833- AND 2833-TYPE TELEPHONE SETS
(4-WIRE RELAY CONNECTIONS)

1.001 This Addendum supplements Section 503-702-110.

1.002 This Addendum is issued to show connecting information for the P-90D145 wiring board used in the modification of the 833- and 2833-Type Telephone Sets for 4-wire operation.

EXHIBIT 1

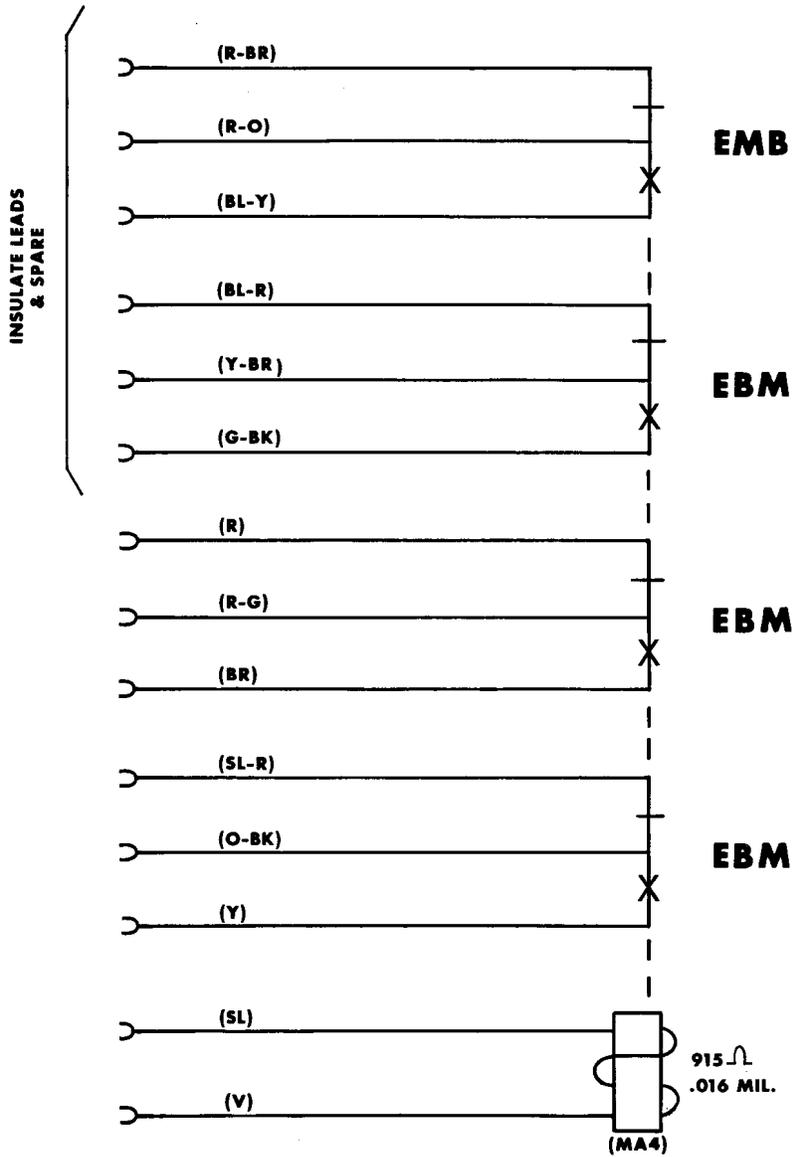
4.003 Exhibit 1 shows the wiring schematic for the P-90D145 wiring board. The relay is mounted on a wiring board containing holes for mounting in the set.
